OHIO TURNPIKE COMMISSION

ADDENDUM NO. 1

**AGREEMENT TRM-9F
REQUEST FOR PROPOSALS FOR
JANITORIAL SERVICES
AT THE INDIAN MEADOW AND TIFFIN RIVER SERVICE PLAZAS**

ISSUE DATE:
March 15, 2011

EXHIBIT A - 4 of 4
 ADDENDUM NO. 1 3-28-11

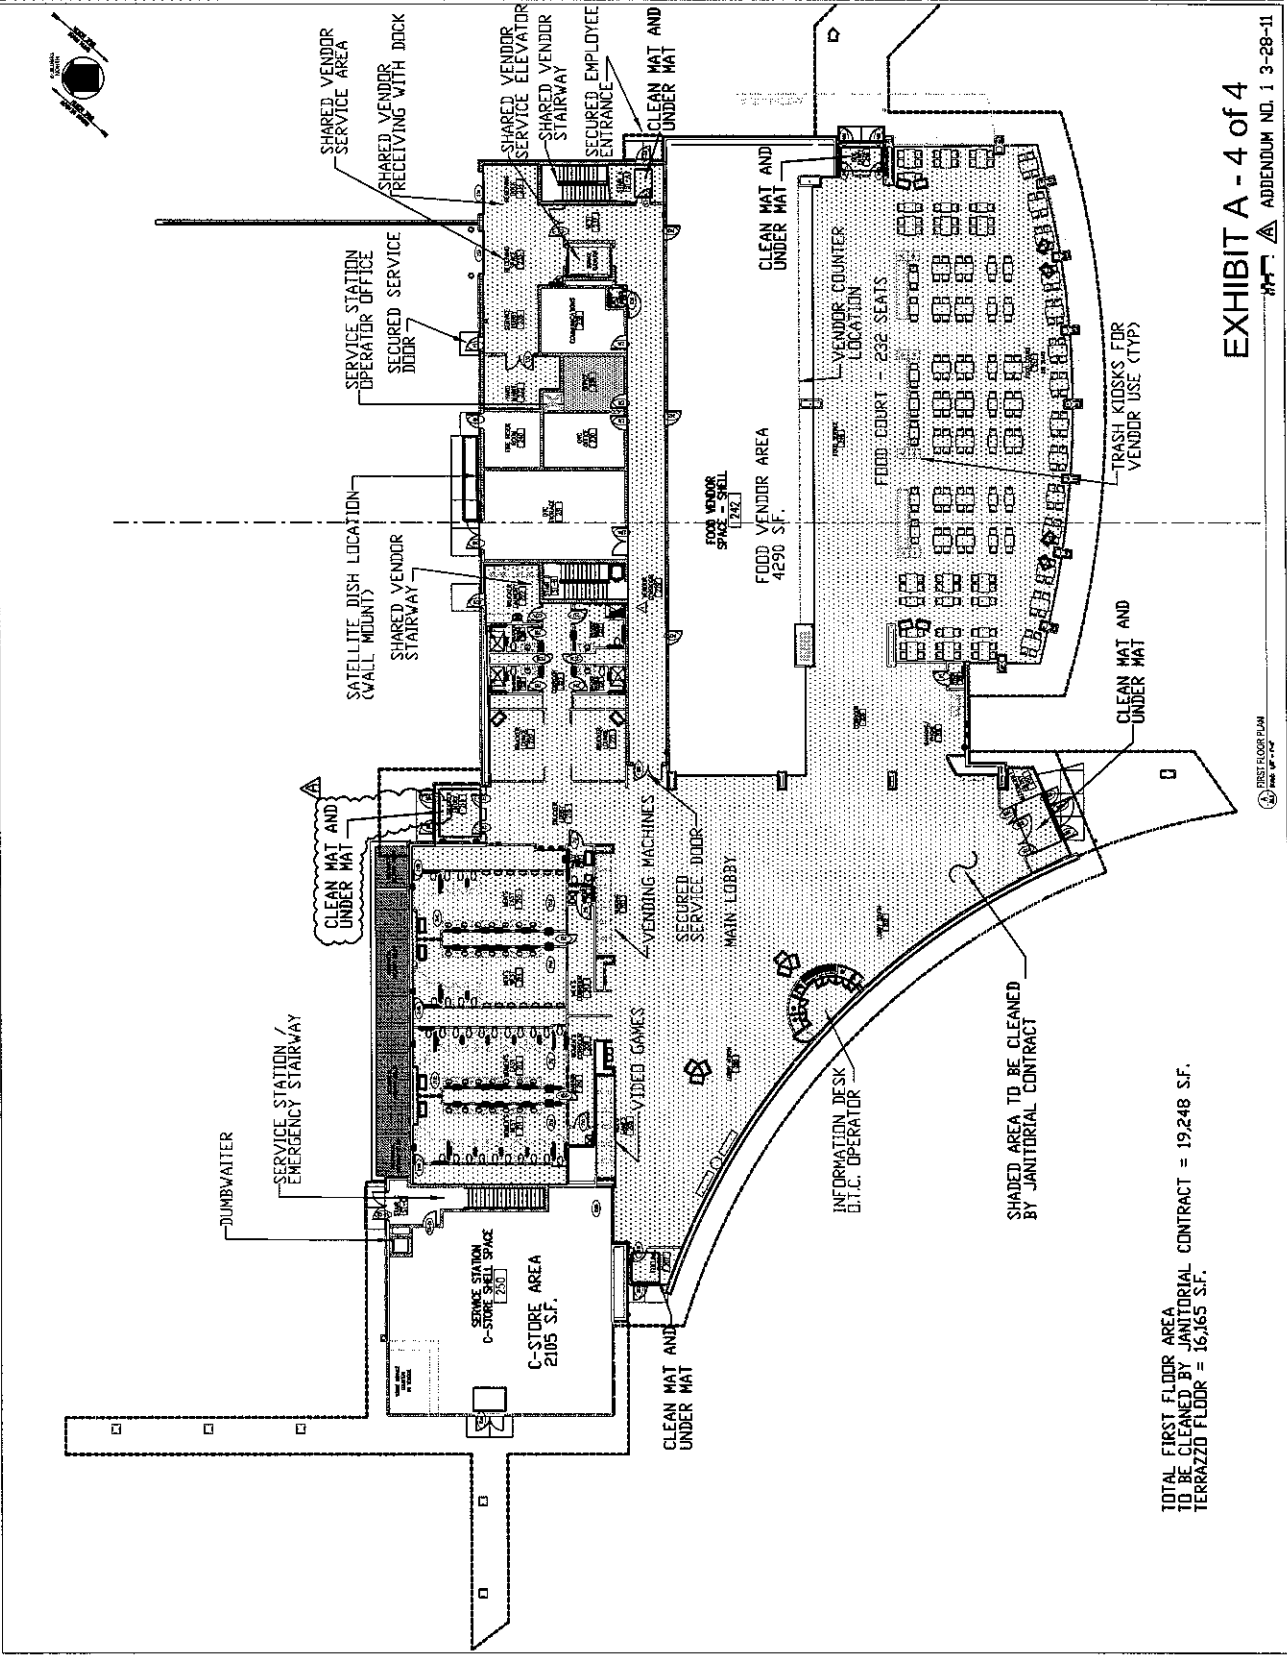
Exhibit A, Areas of Responsibility, Plan Sheet 4 of 4: Please see the new Note added to Plan Sheet 4 of 4 indicating an additional area near the Trucker's Lounge entrance where floor mats must be cleaned and replaced as necessary.
